# Work Order ID 97410

Item Name: Crosstube Turning Detail

<b>DART AEROSPACE LTD</b>	<b>Work Order:</b> 97416
<b>Description:</b> Crosstube Assembly	<b>Part Number:</b> D206-667-243
<b>Inspection Dwg:</b> D206-667-243 Rev: C	<b>Page 1 of 2</b>

DRAWING NO. D206-667-243	TITLE CROSSTUBE ASS'Y (206L HIGH AFT)	REV. C	DART AEROSPACE LTD ENGINEERING ORDER		D.E.O. NO. D206-667-243-C-1	SHEET NO. SHEET 1 OF 1	SCALE NTS
DRAWN 9P	CHECKED ASS	MFG. APPR. RB	APPROVED MD		DE APPR. #		
DATE 11.07.15	DATE 11.07.20	DATE 11.07.21	DATE 11/07/21		DATE 11.07.21

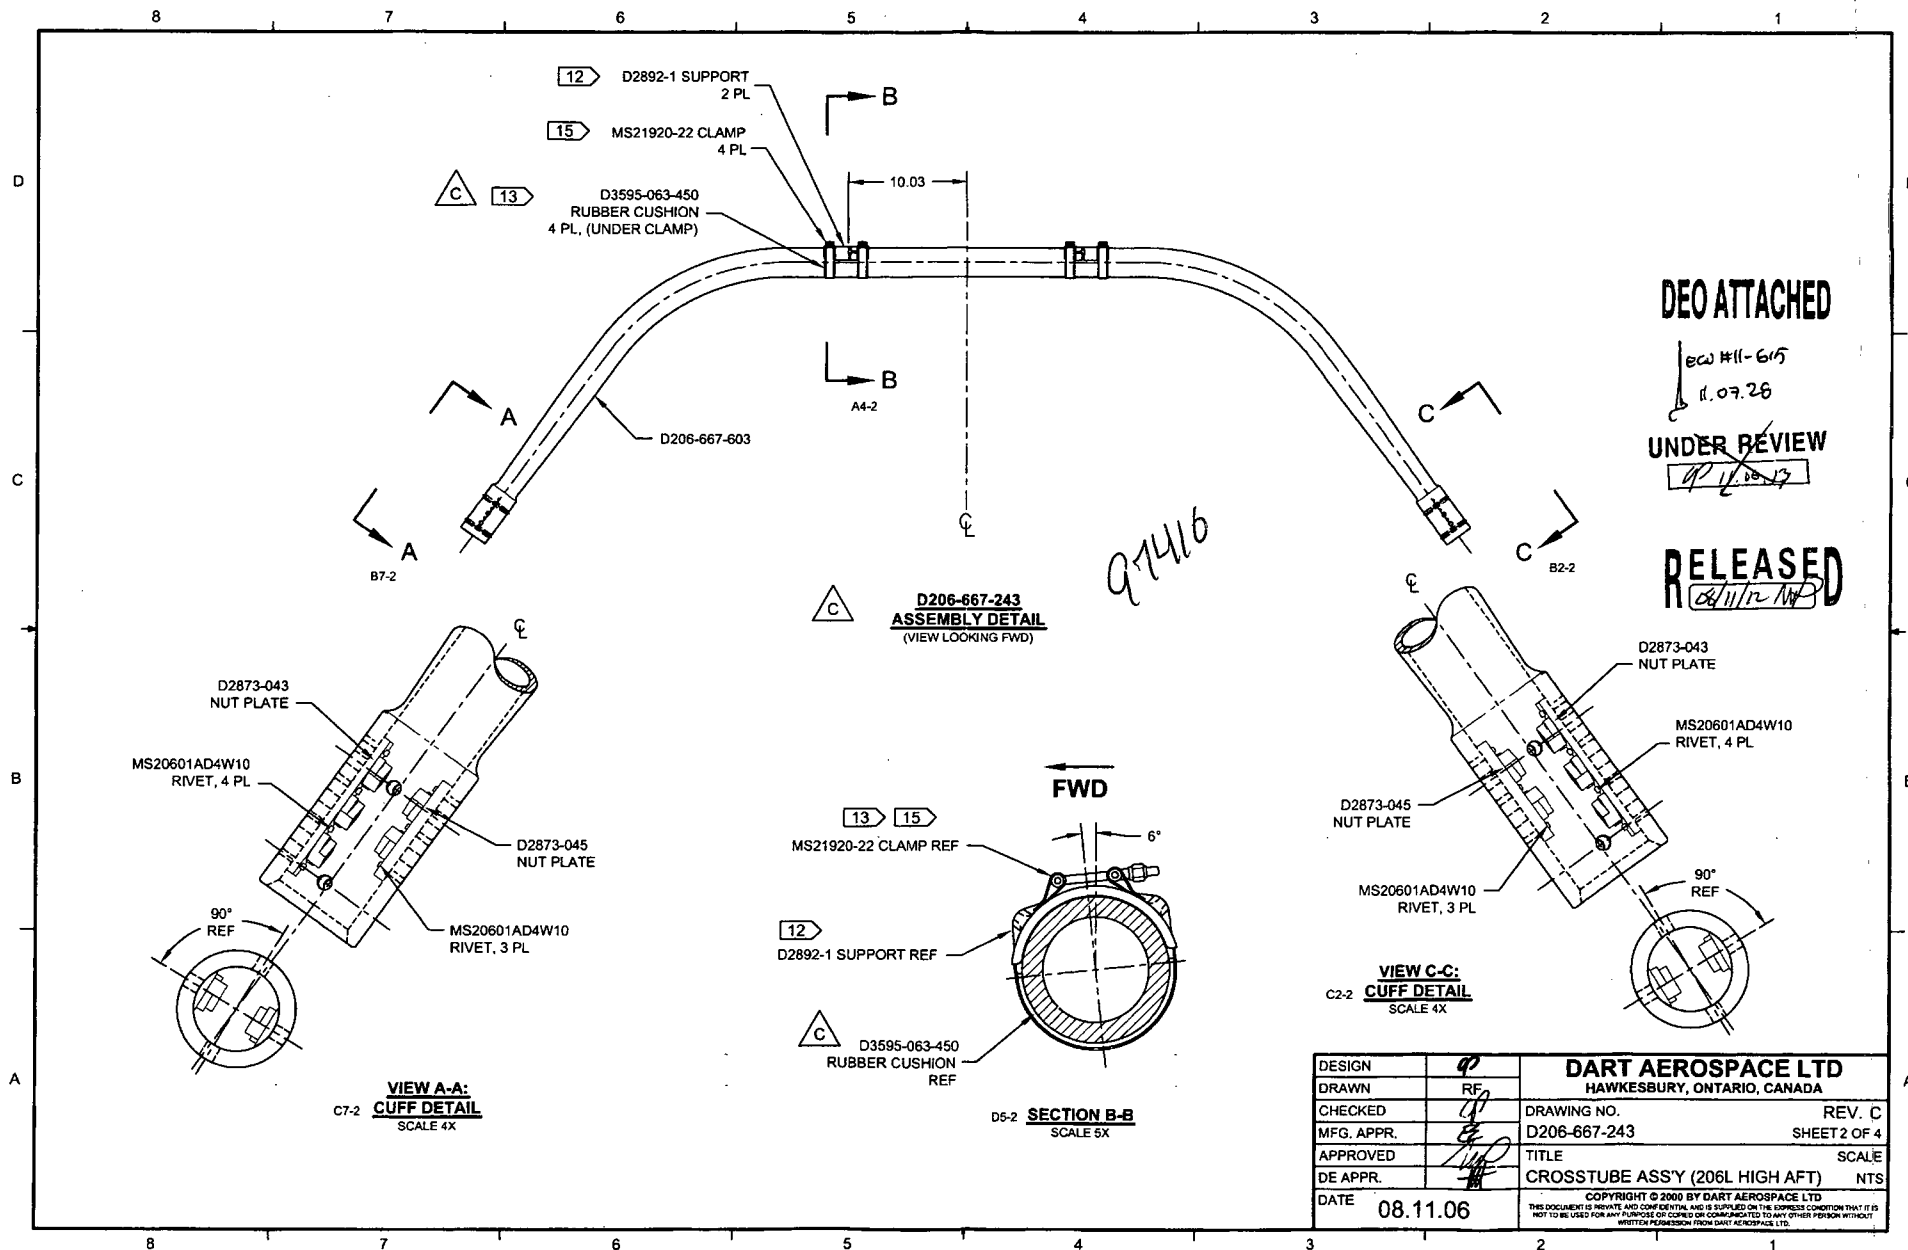
C	REVISE GENERAL NOTES/PART LIST (ZN D7-1); REORGANIZED VIEWS AND REFORMATTED DRAWING TO CURRENT STANDARDS. D3595-063-450 WAS D2856-400-773 (ZN D6-2 & A5-2); REMOVED REF. & ADD TOLERANCES (ZN 4-3, CS-3, D3-3); RELOCATED FLAG #6 (ZN A8-3) PER NCR 210; MOVED TURNING DETAIL & UPDATED TOLERANCE TO SHEET 4.	RF	08.11.06
B	ADD HOLES AND NUT PLATES FOR COMPATABILITY WITH BHT/AA SKUDTUBES	PH	05.07.26
A	NEW ISSUE	CP	00.11.17
REV.	DESCRIPTION	BY	DATE
DESIGN	RF	<b>DART AEROSPACE LTD</b> HAWKESBURY, ONTARIO, CANADA	
DRAWN	RF		
CHECKED	RF	DRAWING NO.	REV. C
MFG. APPR.	RF	D206-667-243	SHEET 1 OF 4
APPROVED	RF	TITLE	SCALE
DE APPR.	RF	CROSSTUBE ASS'Y (206L HIGH AFT)	NTS
DATE	08.11.06	COPYRIGHT © 2000 BY DART AEROSPACE LTD THIS DOCUMENT IS PRIVATE AND CONFIDENTIAL AND IS SUPPLIED ON THE EXPRESS UNDERSTANDING THAT IT IS NOT TO BE USED FOR ANY PURPOSE OR COPIED OR COMMUNICATED TO ANY OTHER PERSON WITHOUT WRITTEN PERMISSION FROM DART AEROSPACE LTD
